# J.R. Holzmacher P.E., LLC

November 14, 2012

**Re:** 12CVCP092K  
E-Des # 12EHAZ452K  
10504 Flatlands Avenue  
Remedial Action Work Plan (RAWP) Stipulation List

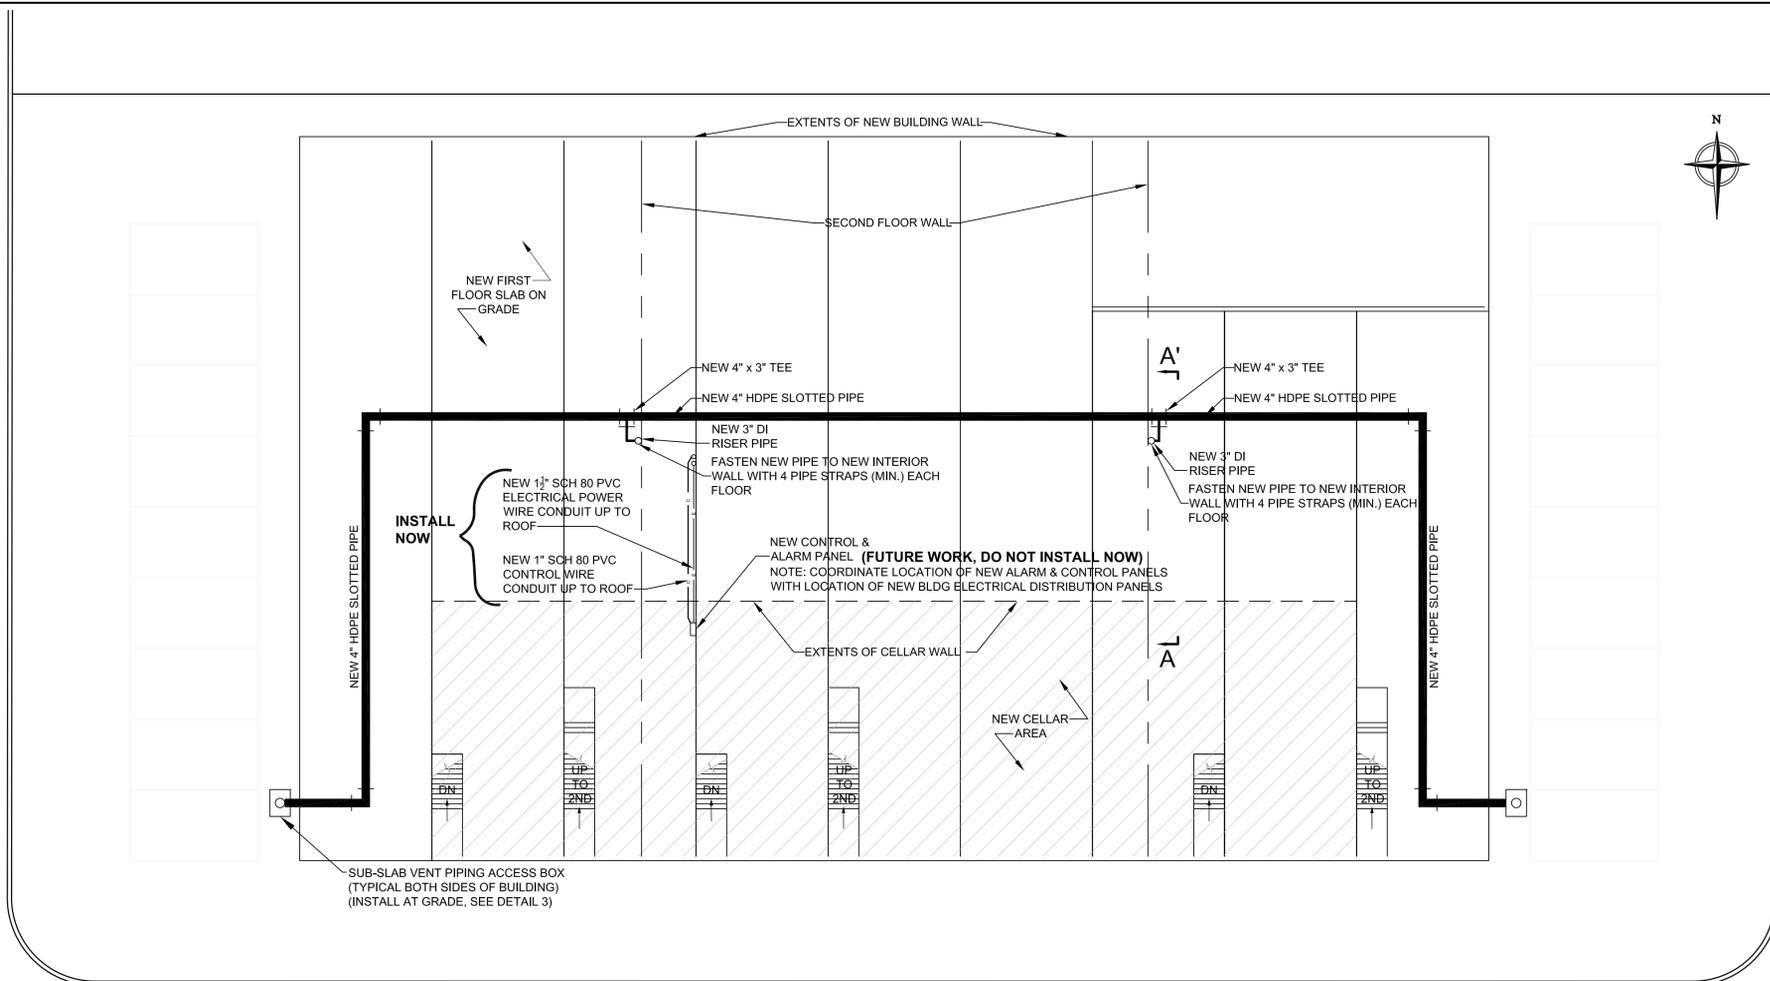
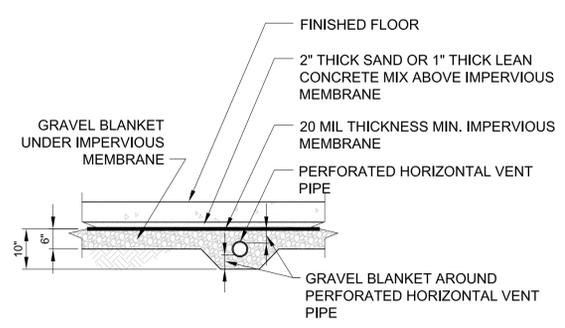
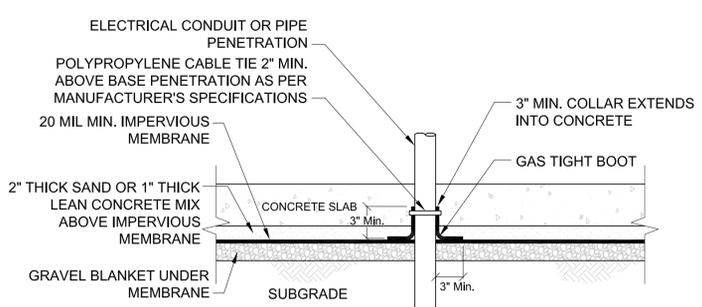
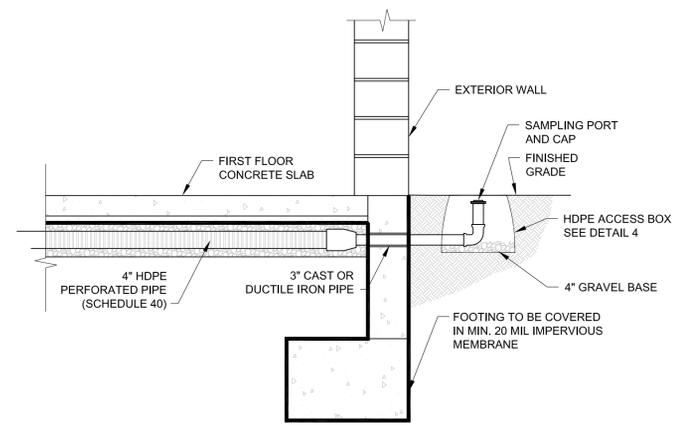
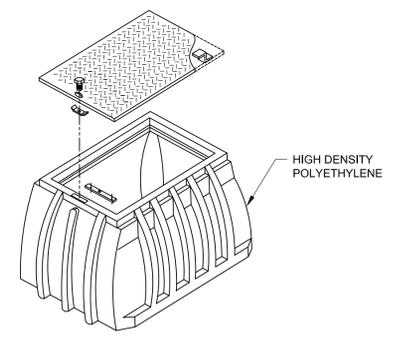
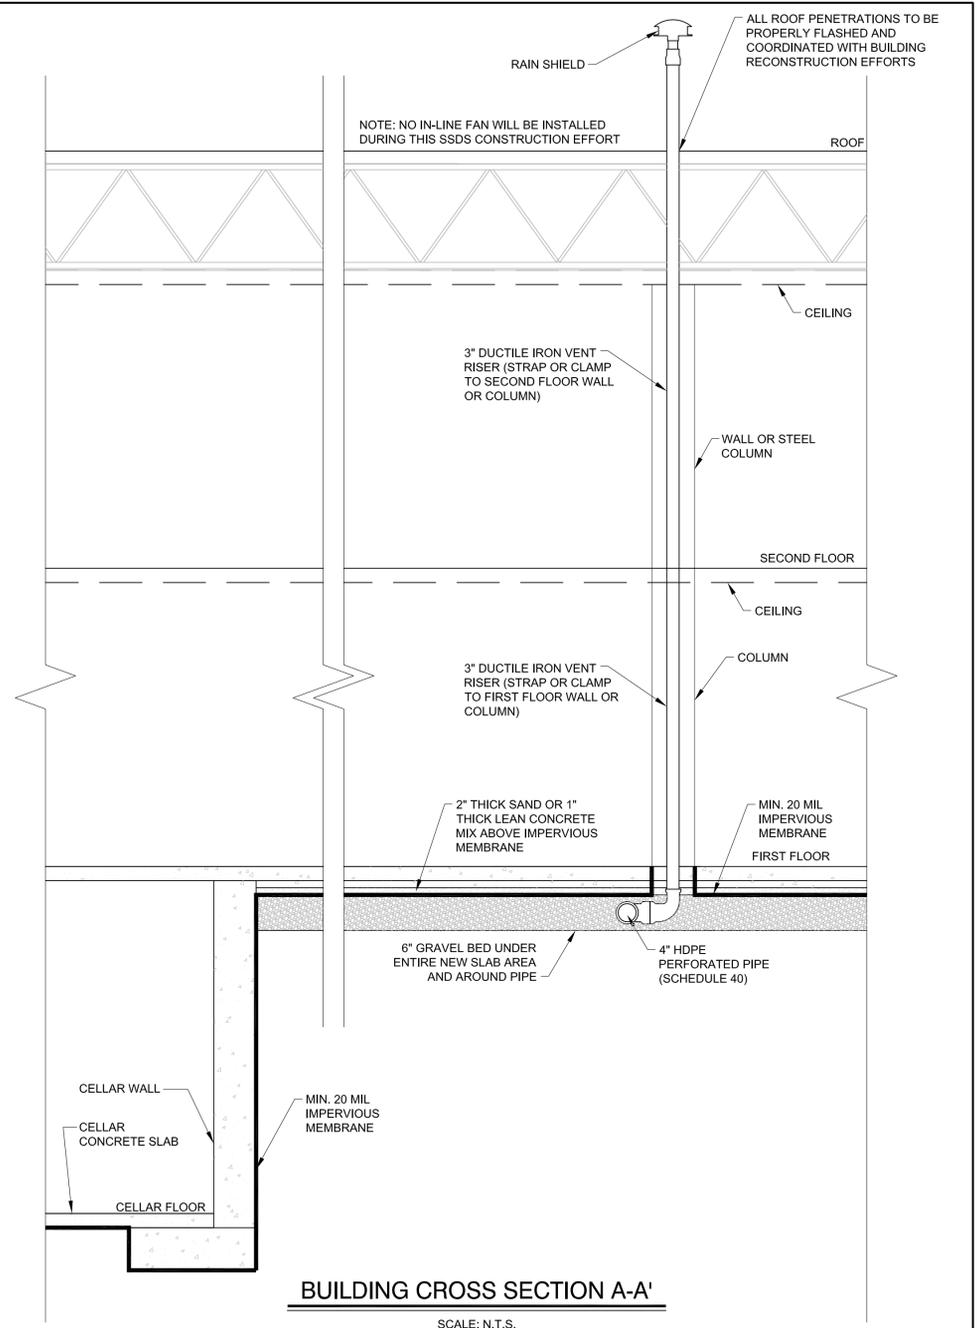
8. Section 4.3 of the RAWP indicates that the cellar of the building will be built to the groundwater interface. Therefore, a sub-slab depressurization system (SSDS) will be constructed beneath the slab-on-grade areas of the proposed building, but not beneath the partial on-site cellar. A passive SSDS is designed to mitigate any potential sub-slab gases. The system will consist of new 4-inch HDPE slotted pipe, 3-inch ductile iron vent risers and a sub-slab vent piping access box located at grade on the exterior of the building footprint. **Appendix 3** provides PE/RA certified building plans with SSDS installation details (sub-slab matrix, piping configuration, risers, depressurization mechanism, etc.) with respect to the proposed building foundation, footings, slab, and sidewalls.

**Appendix 4**  
Vapor Barrier Design and Details

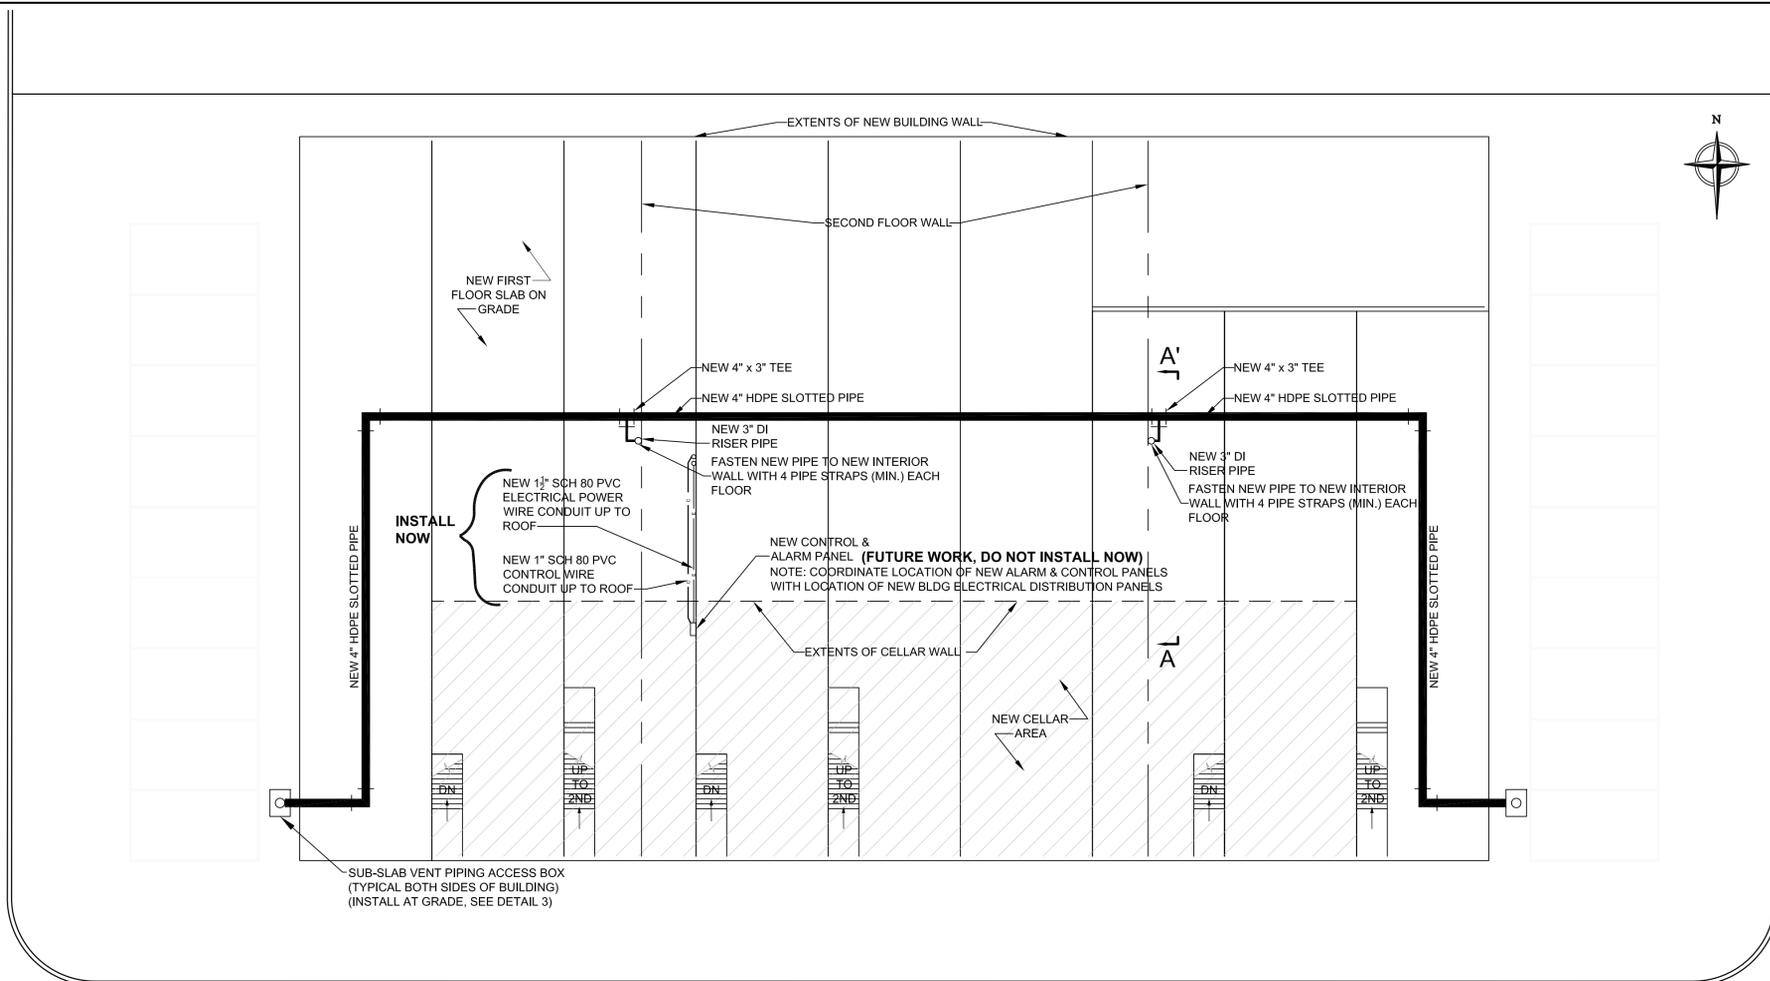
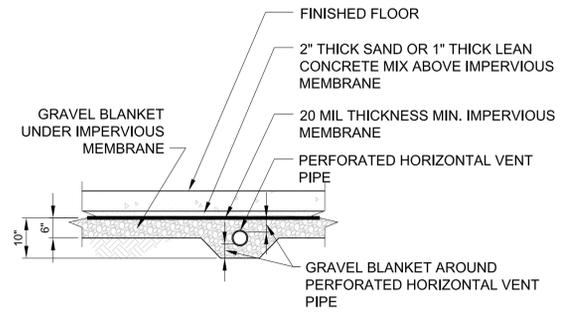
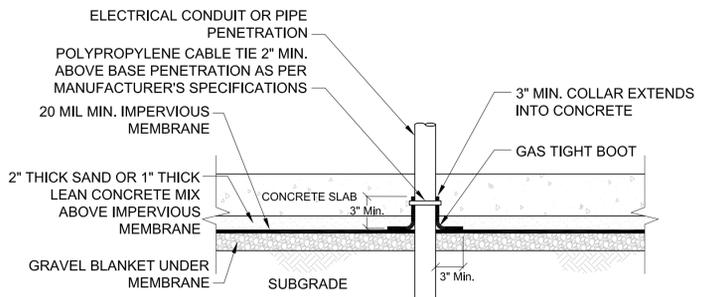
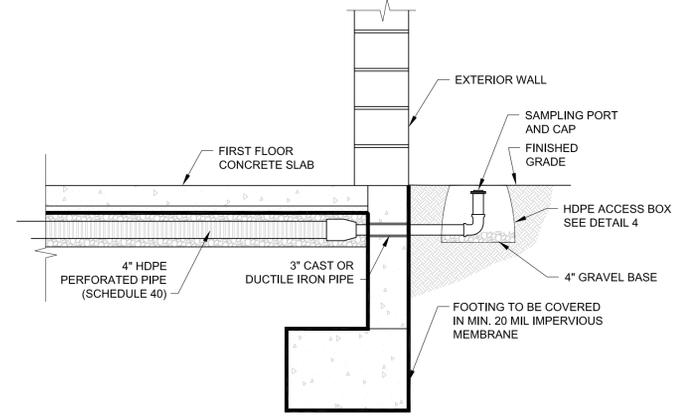
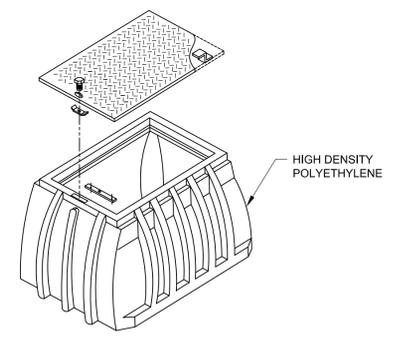
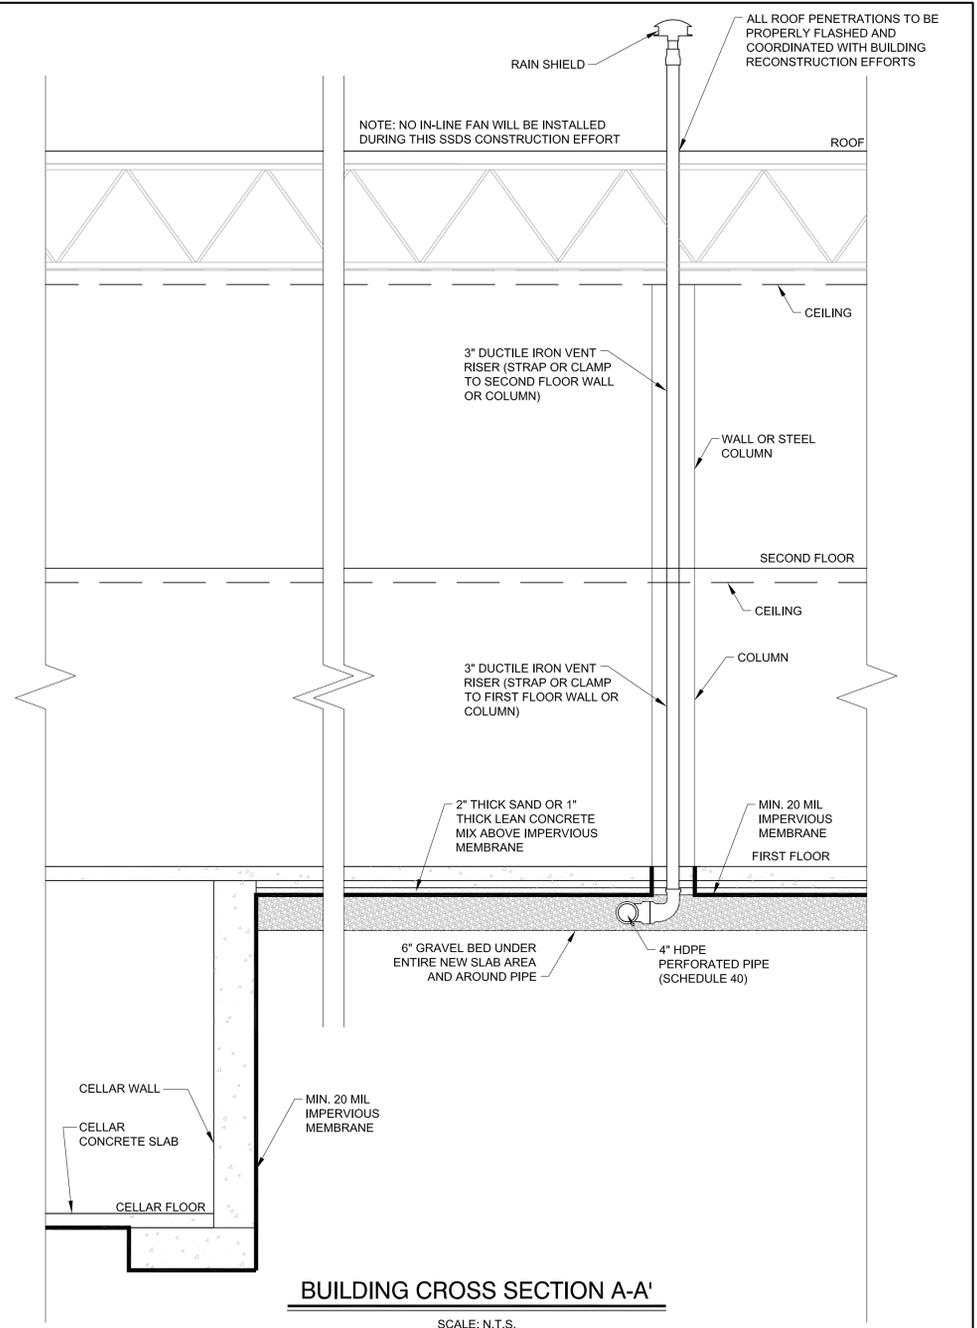
9. Section 4.3 of the RAWP describes the VaporBlock Plus VBP 20-mil vapor barrier, manufactured by Raven Industries that will be installed beneath the structure's slab and along foundation sidewalls. **Appendix 4** provides PE/RA certified building plans with the extent of the vapor barrier installation details (penetrations, joints, etc.) with respect to the proposed foundation, footings, and the hydraulic lift station slab.

SEAL	DATE 11-12-12
	PROJECT NO.: JB-462-01
	DRAWING BY: DC
	CHK BY: DC
	DRAWING NO.: Z-001.00
	3 OF 4

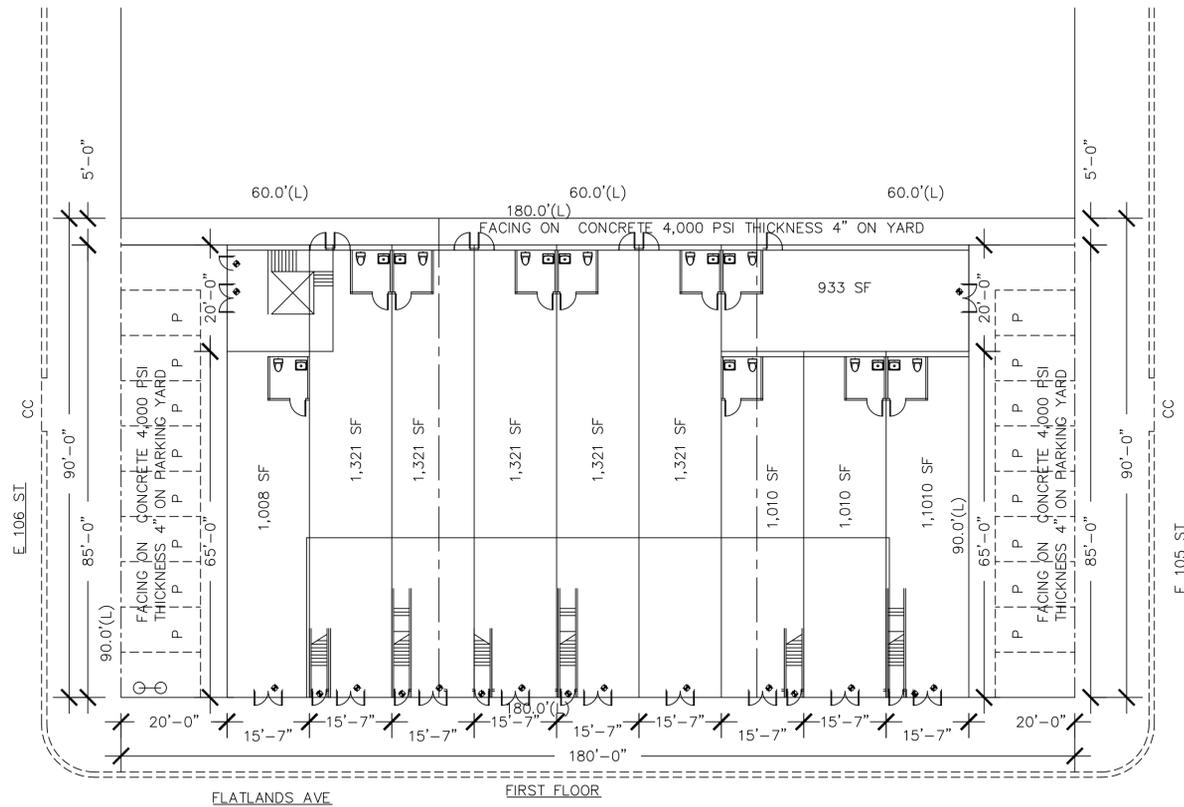
10. An engineered composite site cover will be placed over the entire footprint of the Site. The composite cover system will be comprised of asphalt covered parking areas, concrete covered sidewalks, and a concrete building slab. PE/RA certified drawings of the composite site cover are provided as **Appendix 5**. Sheet Z-001.00 in **Appendix 5** shows

the typical design for the remedial cover type to be used on this site and the location of each cover type to be built at the site, respectively.
